Form 3160-5
(June 2019)

8. Well Name and No.
HAWK 35 FED/202H

EOG respectfully requests an amendment to our approved APD for this well to reflect the following changes:

Hawk 35 Fed 104H (FKA 202H) API #: 30-025-47892

Revised Wellbore A:

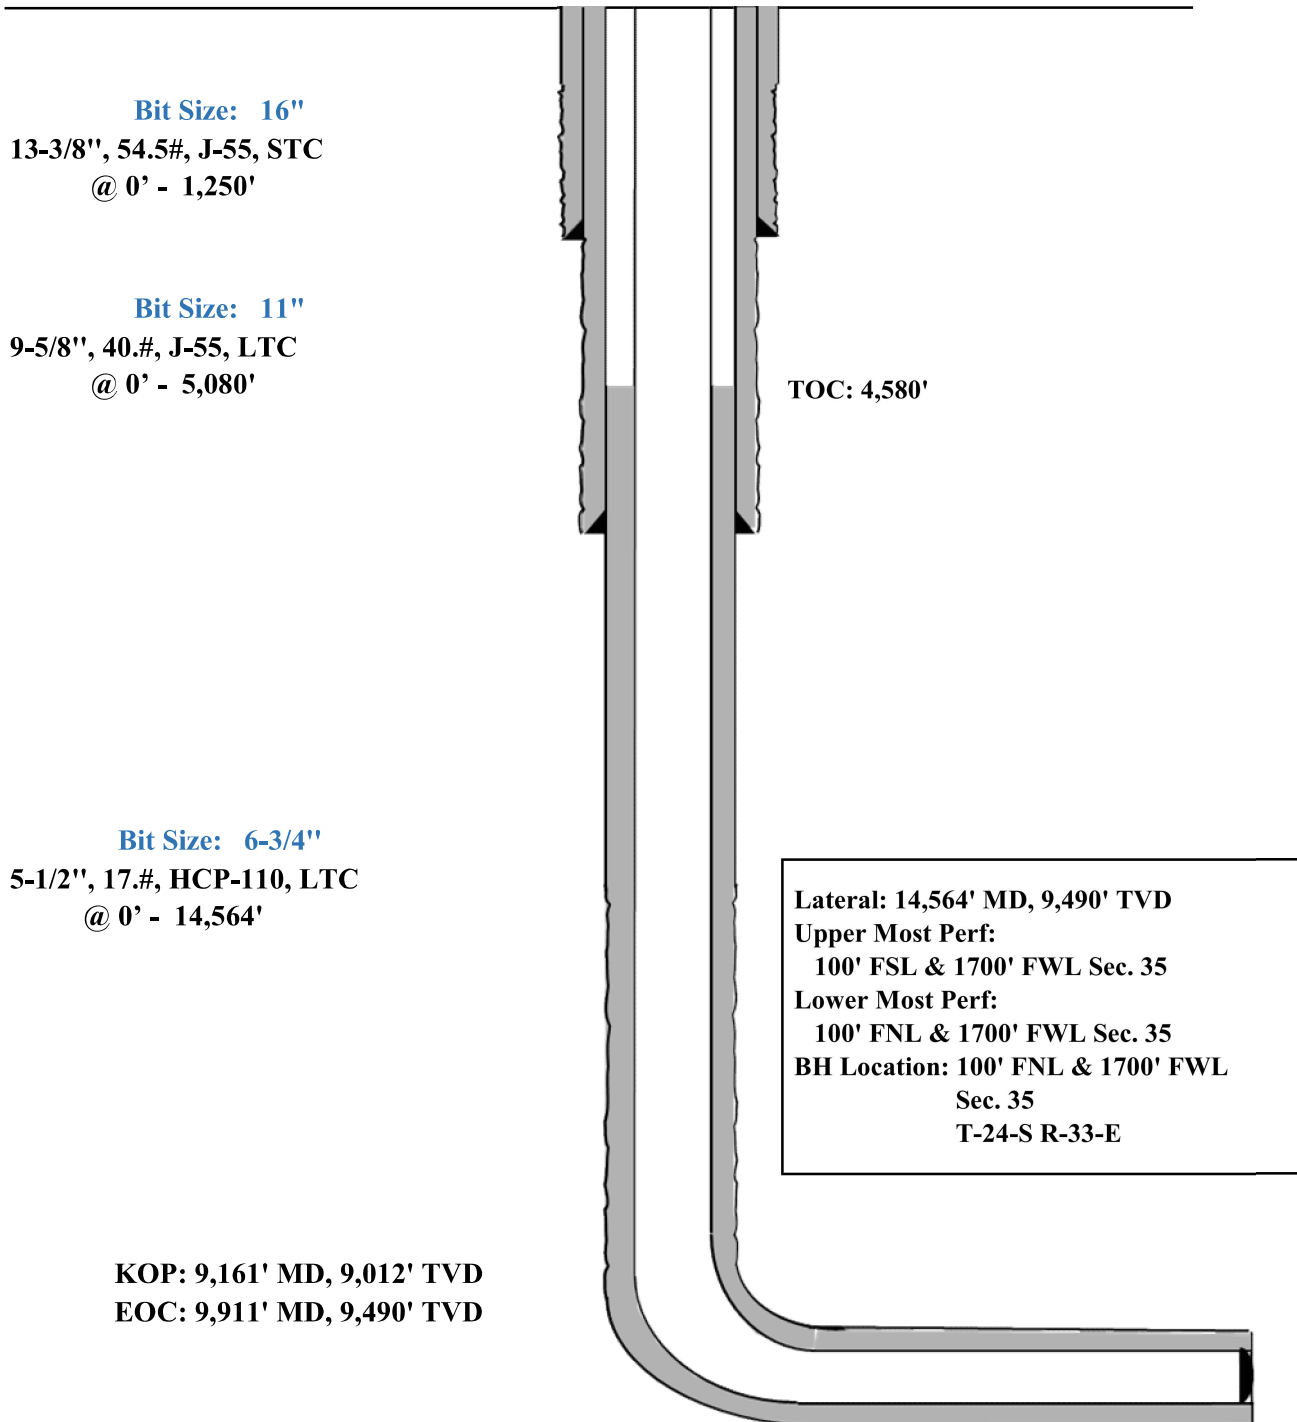
Casing Program A:

Hole Size	Interval MD		Interval TVD		Csg OD	Weight	Grade	Conn
	From (ft)	To (ft)	From (ft)	To (ft)				
16"	0	1,250	0	1,250	13-3/8"	54.5#	J-55	STC
11"	0	5,236	0	5,080	9-5/8"	40#	J-55	LTC
6-3/4"	0	14,564	0	9,490	5-1/2"	17#	HCP-110	LTC

Variance is requested to waive the centralizer requirements for the 9-5/8" casing in the 11" hole size. An expansion additive will be utilized, in the cement slurry, for the entire length of the 11" hole interval to maximize cement bond and zonal isolation.

Variance is also requested to waive any centralizer requirements for the 5-1/2" casing in the 6-3/4" hole size. An expansion additive will be utilized, in the cement slurry, for the entire length of the 6-3/4" hole interval to maximize cement bond and zonal isolation.

EOG requests permission to allow deviation from the 0.422" annulus clearance requirement for the intermediate (salt) section from Onshore Order #2 under the following conditions:

Vertical Section at 345.48°

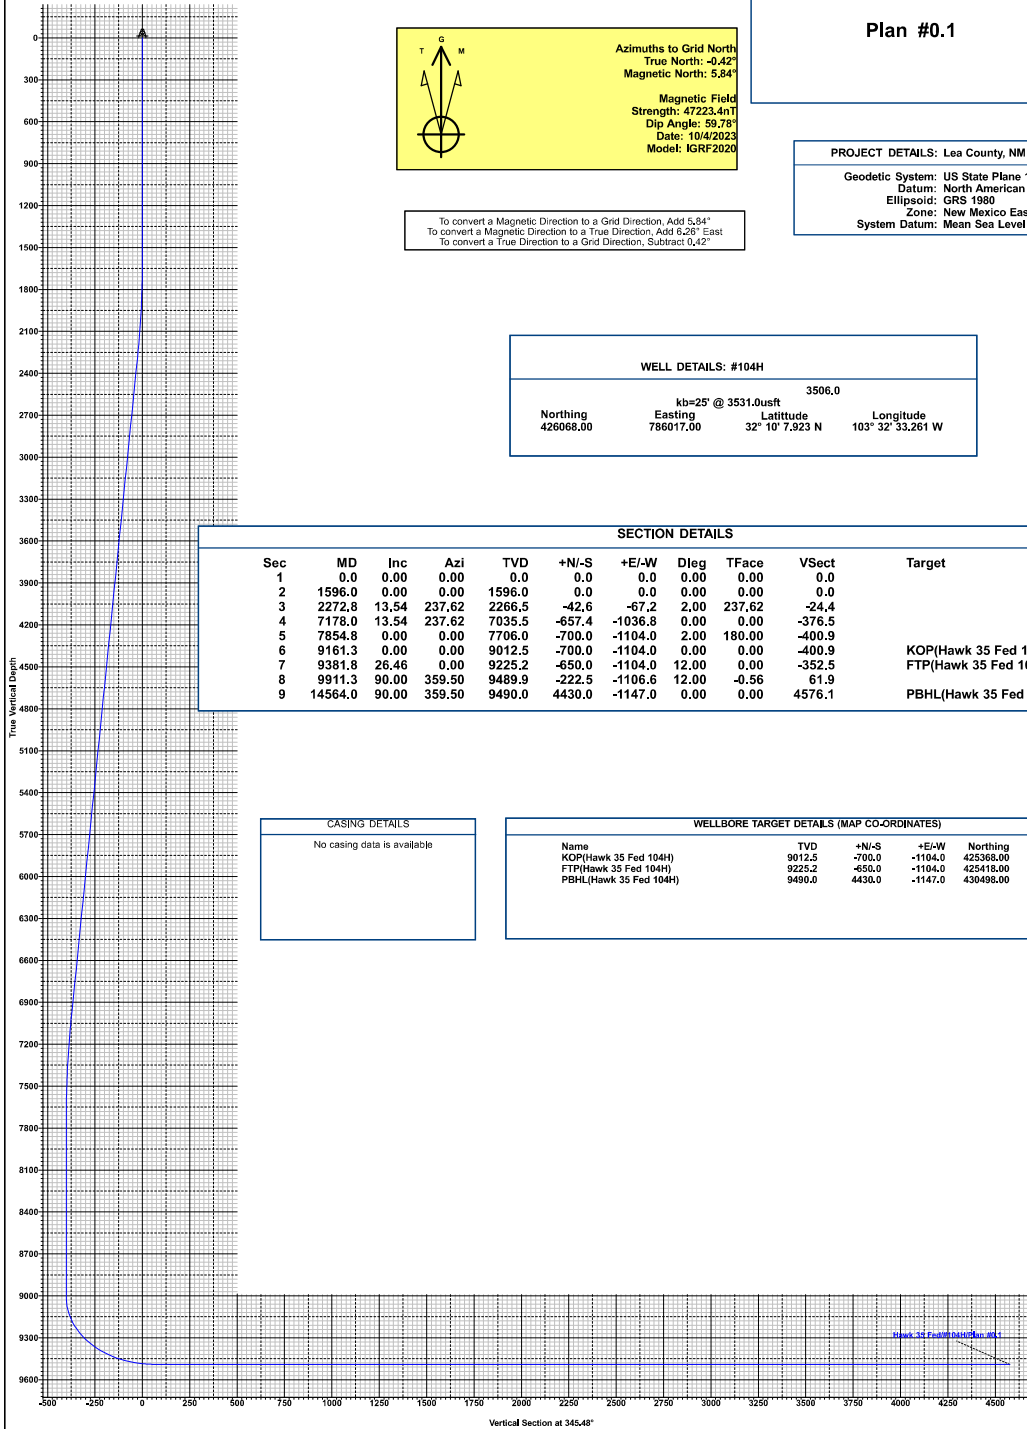
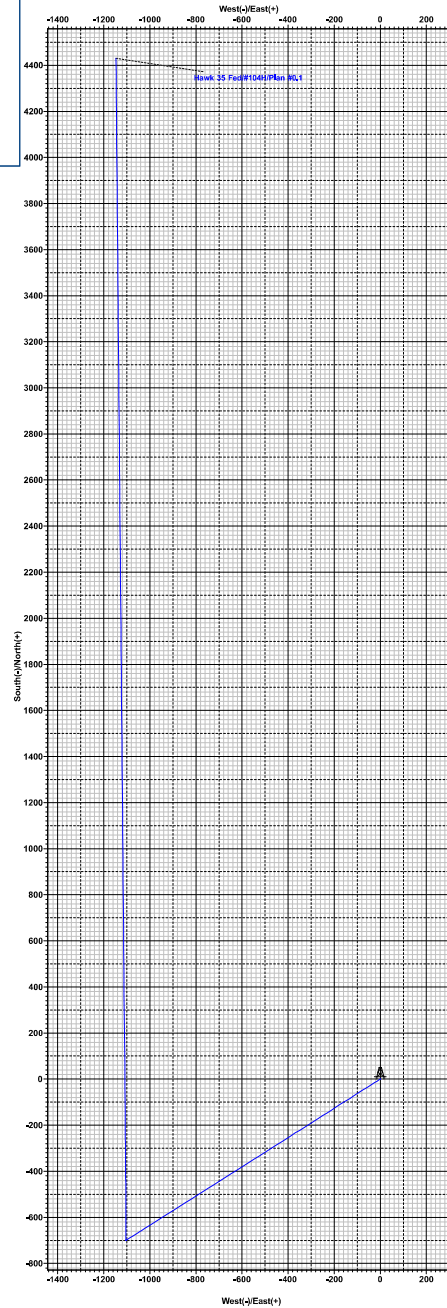
Change name from Hawk 35 Fed 202H to Hawk 35 Fed 104H.

Change SHL from T-24-S, R-33-E, Sec 35, 680' FSL, 1475' FWL, Lea Co., NM, to T-24-S, R-33-E, Sec 35, 742' FSL, 2474' FEL, Lea Co., N.M.

Change BHL from T-24-S, R-33-E, Sec 26, 100' FNL, 830' FWL, Lea Co., NM, to T-24-S, R-33-E, Sec 35, 100' FNL, 1700' FWL, Lea Co., N.M.
